Re:- Your Planning Application reference APP/21/00969

Neighbour comments on Proposed Amendments to Proposed Garden Dwelling

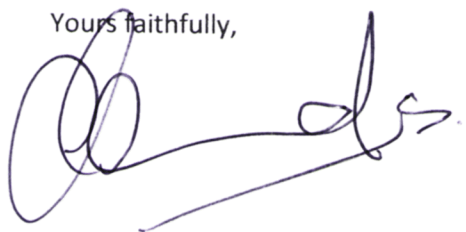
2. Boundary Gap. The amendments include moving the proposed new dwelling away from the boundary wall that we own. This addresses our point that relying on our boundary wall is unacceptable and unlawful, with the addition of brickwork course to our wall without our permission being pursued outside of the planning process. However, the new dwelling has been moved only to create the smallest of corridors from our boundary wall and the eastern elevation wall of the proposed new dwelling. This gap will be insufficient to allow for maintenance of the building and the dividing land without unacceptable (and wholly unavailable) reliance upon our wall

and/or trespass onto it or from our land. IF planning permission is to be pursued then the gap must be at least 1.5m to allow for land and building maintenance;
